## Addendum #2

Directorate of Facilities Engineering

4 January 2022

**Bog Brook Kitchen Renovation, Gilead, Maine, Project Number 23TR19-603-D, BGS Project Number 3195, Bid Number 22-017.**

EXTERIOR ELEVATIONS 1

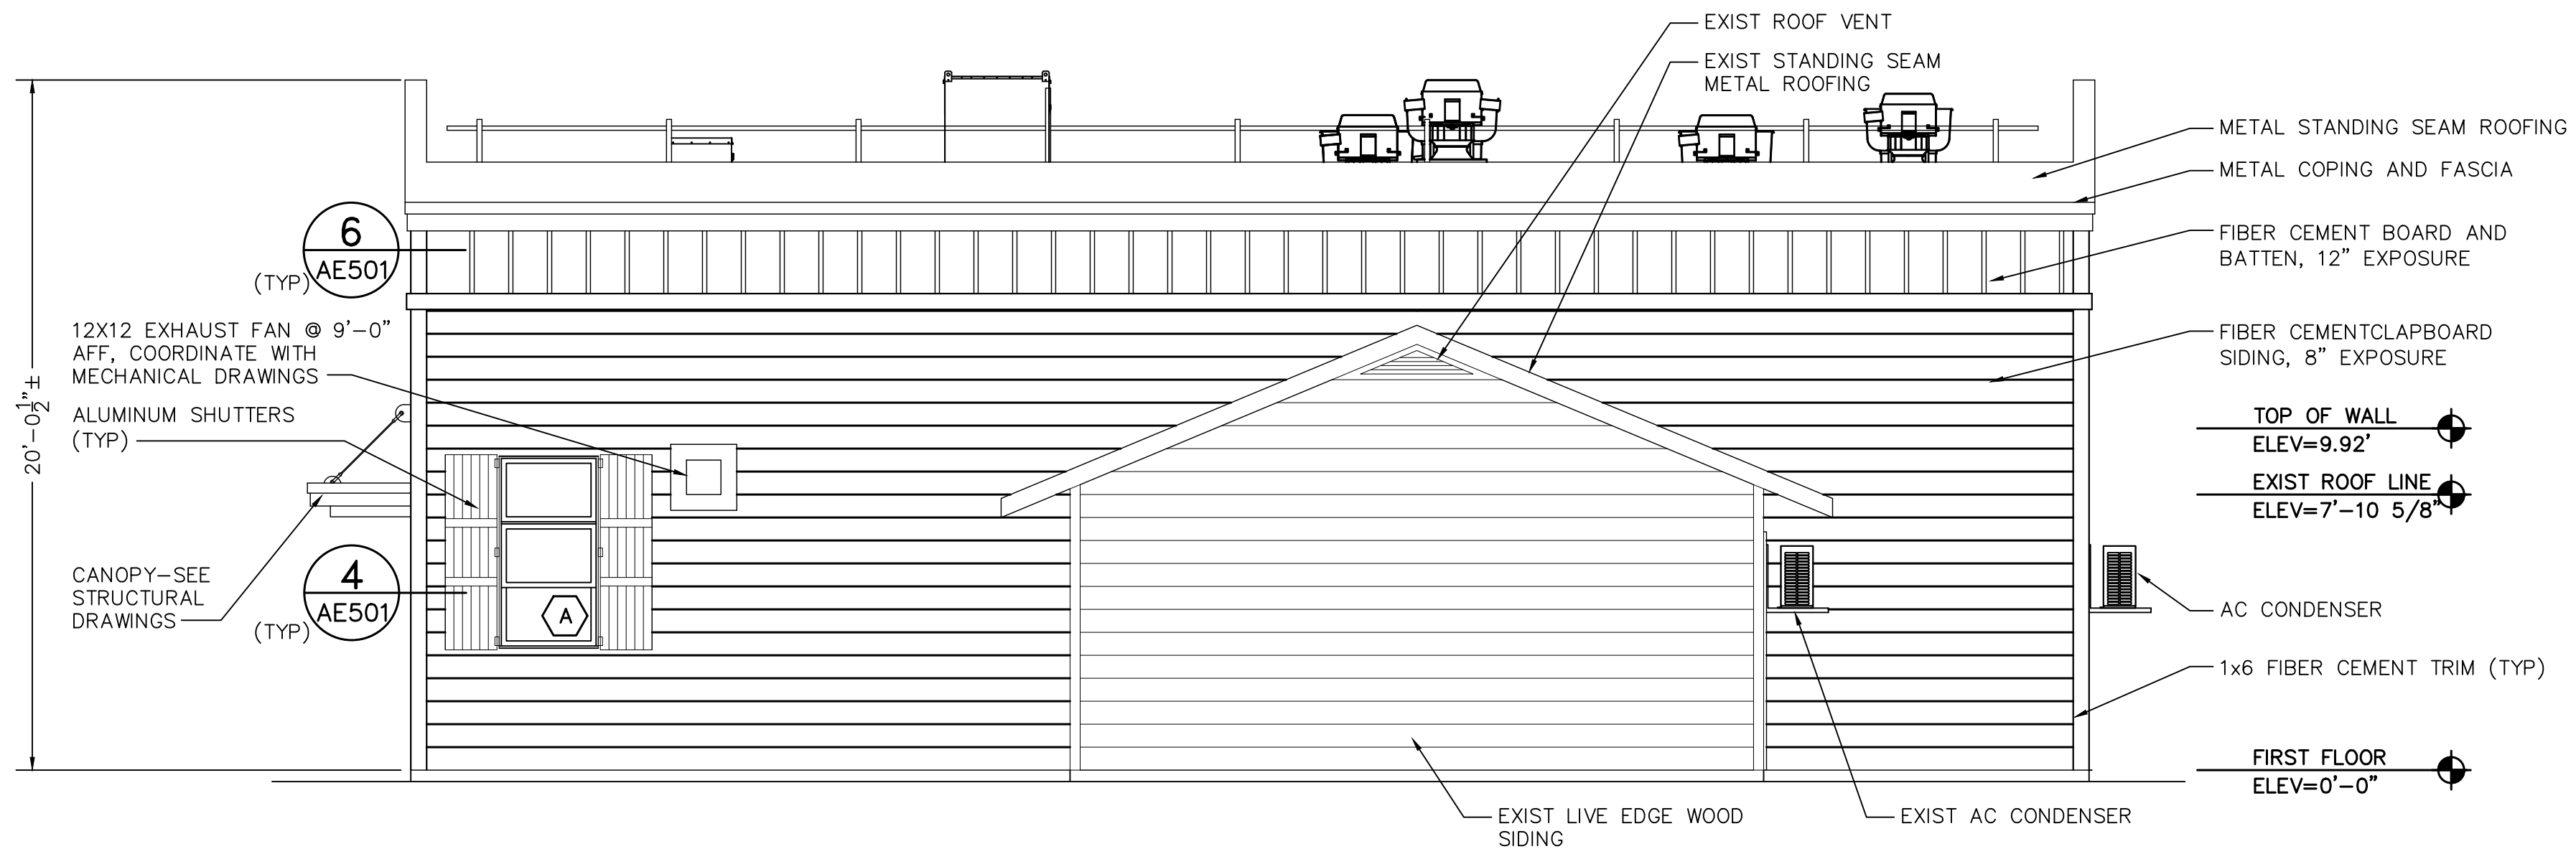
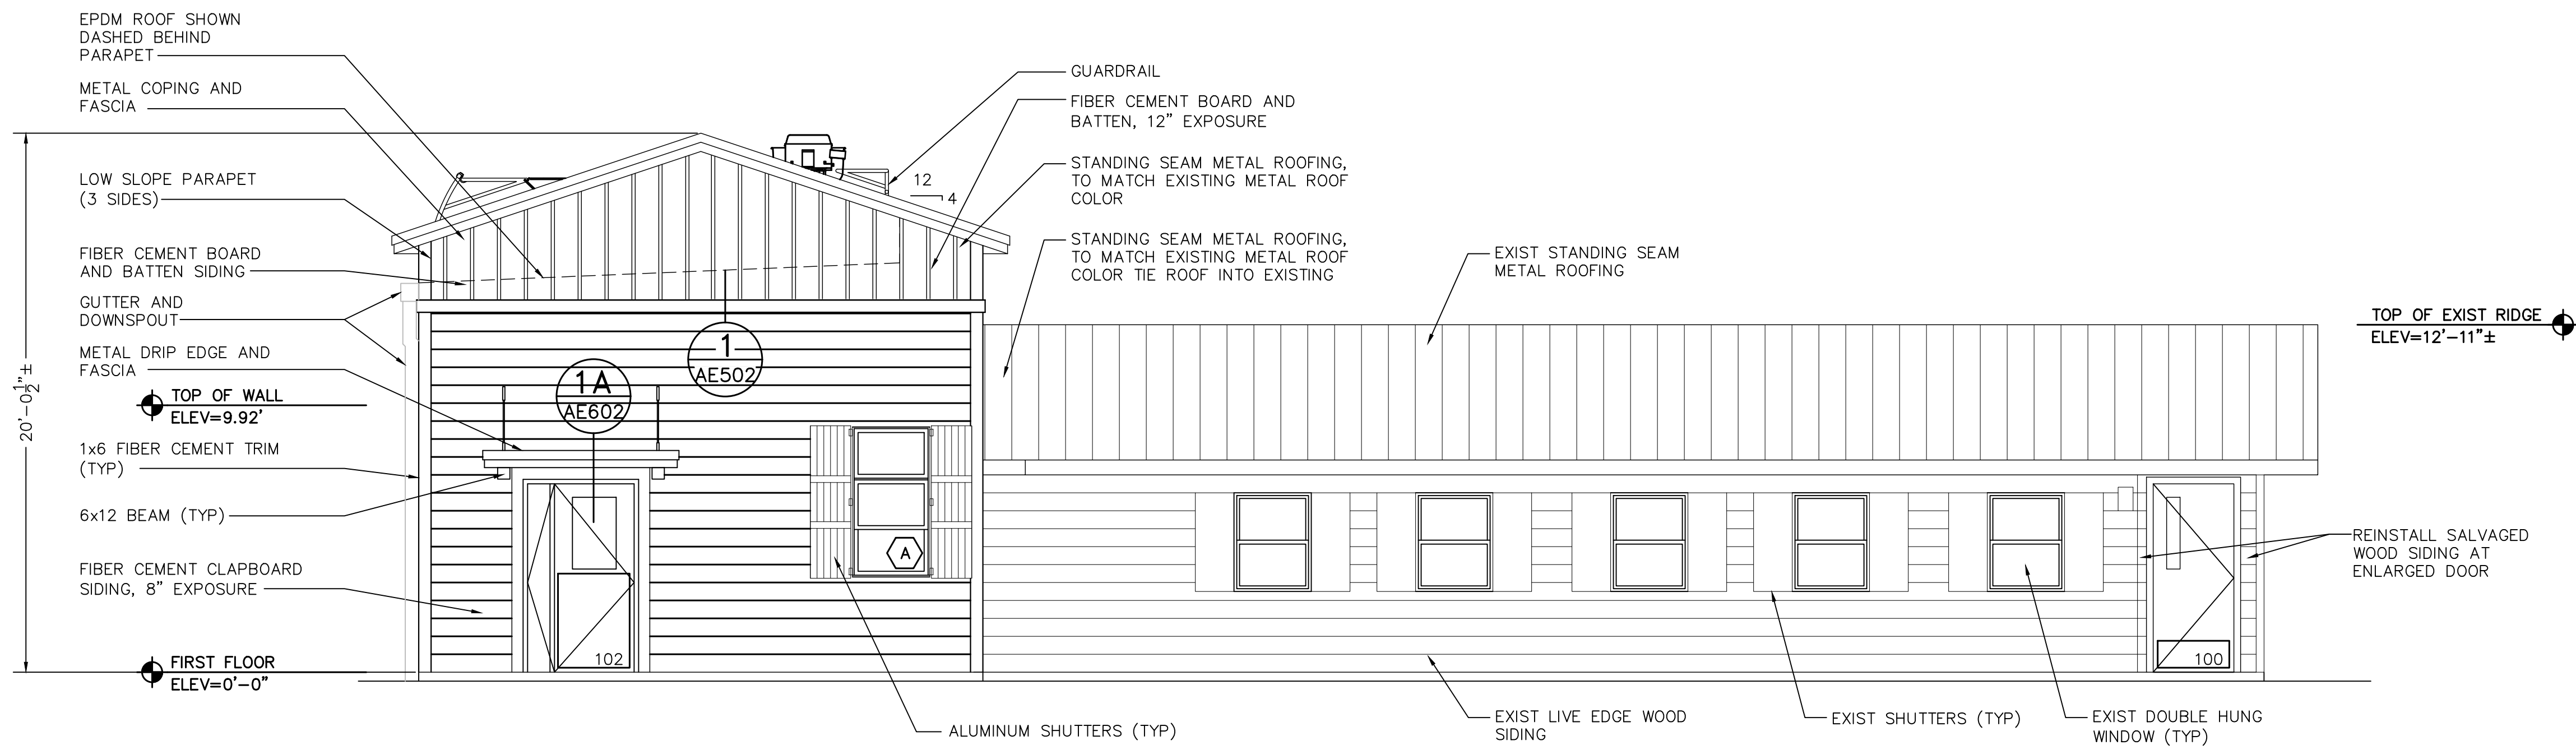
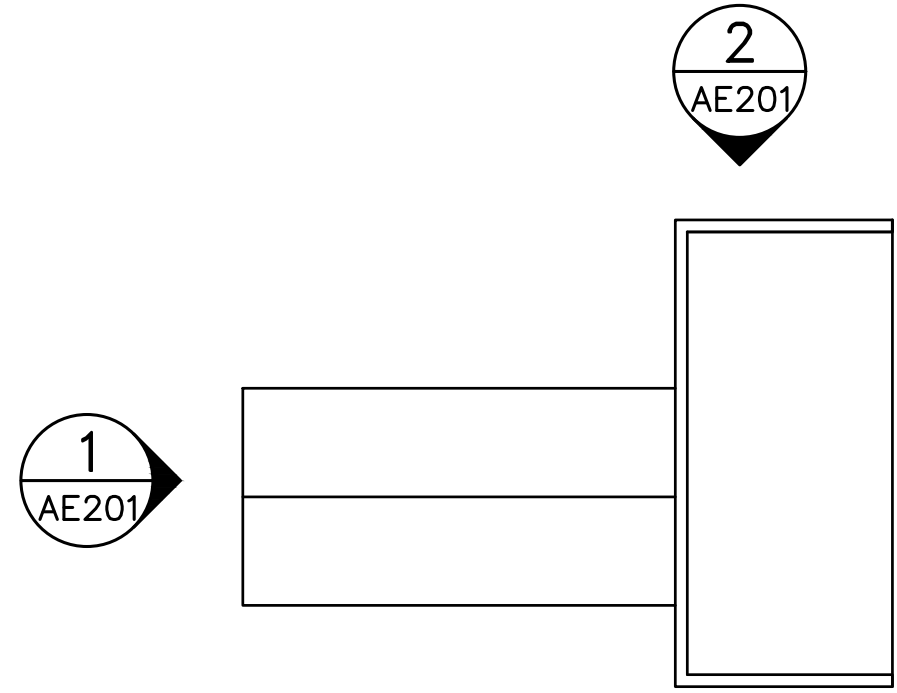
**Answer:** Provide the panels as specified.
6. **Question:** Section 074646 Fiber-Cement Siding 2.2-D states that batten trim is to be 8” on center. The elevation plans show this to be 12” on center. Please clarify?

7. **Question:** Is the fiber-cement siding and trim to be painted, or come pre-finished? The specification says “Factory Priming: Manufacture’s Standard”. I am awaiting information on the standard from a supplier, but if they do not come pre-finished they will need to be finished in the field which is not shown in the plans. Please clarify?

**Answer:** Specification will be corrected to state “12 inches on center.

**Answer:** Fiber-Cement siding and trim is to be factory primed as specified and field painted per specification 099113 Exterior Painting. A general note will be added to the drawings to indicate field painting over factory primed finish.

GENERAL NOTE:  
1. FACTORY PRIMED FIBER CEMENT MATERIALS ARE TO BE FIELD PAINTED.

DOOR/ROOM/SIGNAGE SCHEDULES AND DOOR/WINDOW TYPES

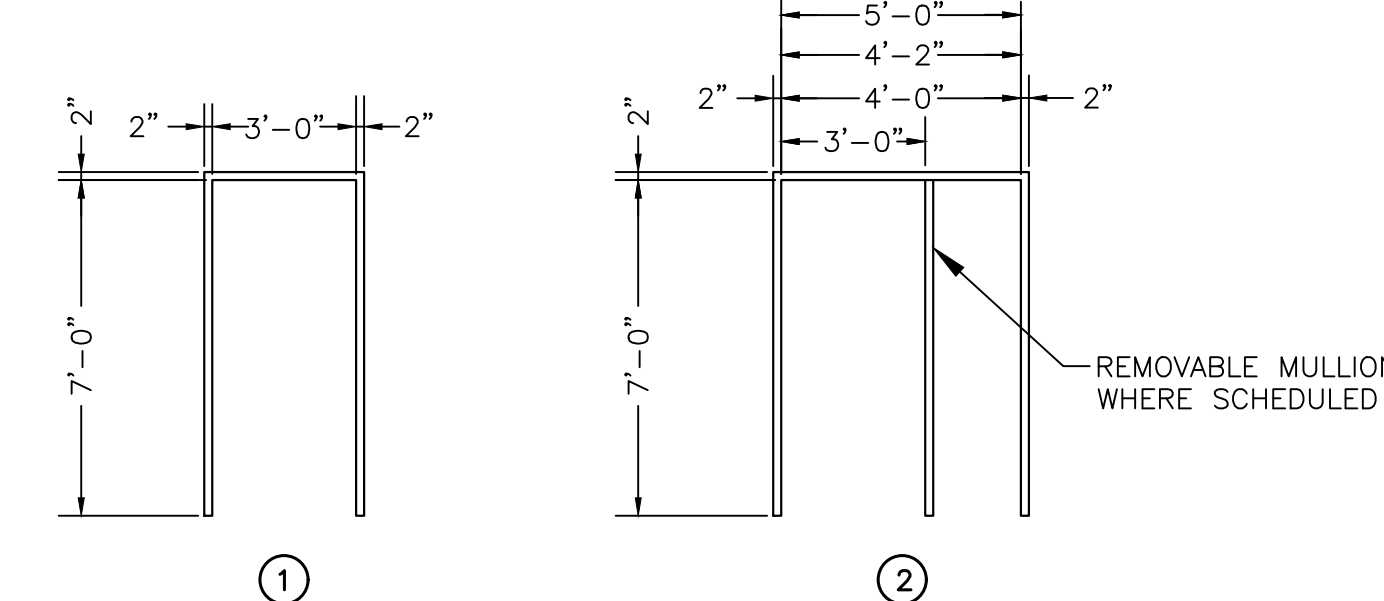
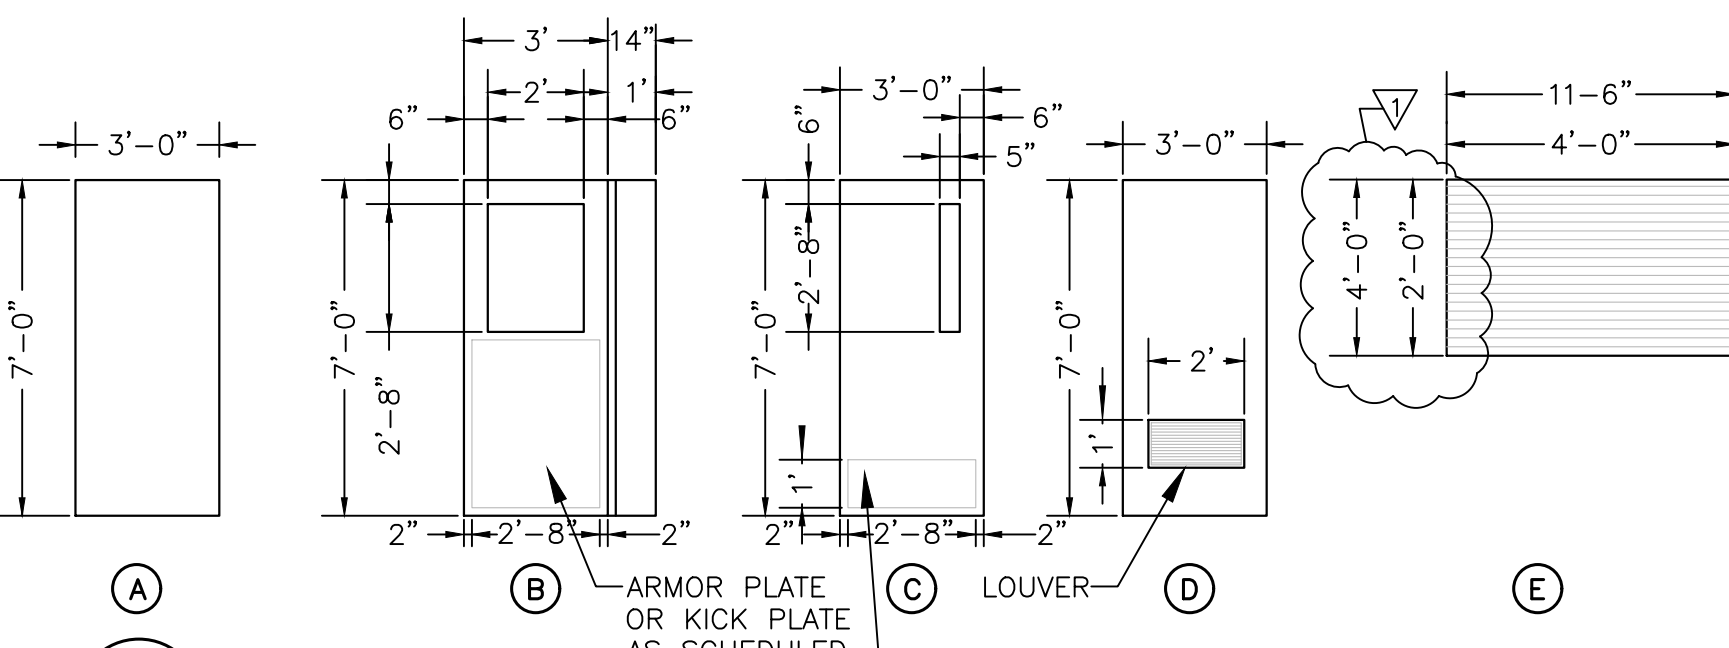
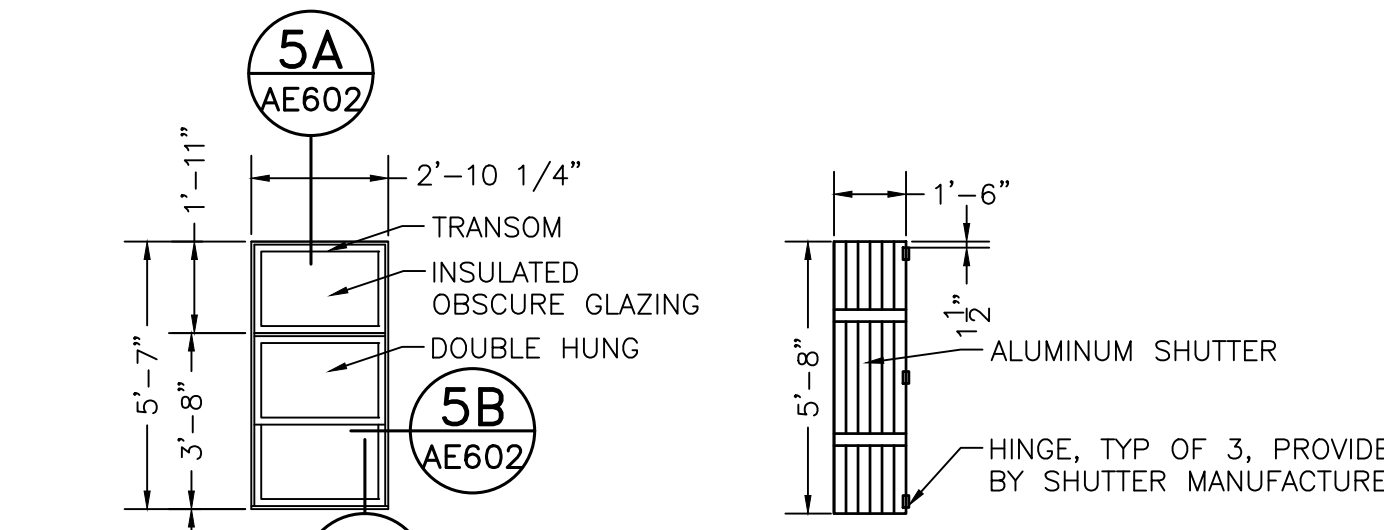
2. **Question:** I have a little confusion between specs, and plans On AE 601 it list note 1 which has the coiling door activated by fire alarm On AE 602 item 4 details show both door units as surface mounted In the spec it mentioned integral metal sill and also has hood, frame, fascia integral And I do not see anything in the spec about fire alarm tie in and it is chain hoist operation Can you please let me know which way to bid?

**Answer:** Coiling door is not activated by fire alarm, note will be deleted. Both units are surface mounted. Integral metal sill is not required, sill is included in Kitchen Equipment. Chain hoist operation is to be provided as specified.

- DOOR SCHEDULE NOTES:**
- COORDINATE COILING DOOR INSTALLATION WITH KITCHEN EQUIPMENT INSTALLATION.
  - DEADBOLT TO HAVE THUMB TURN ON BATHROOM SIDE OF DOOR.
  - INSULATED EXTERIOR METAL DOOR SYSTEM.
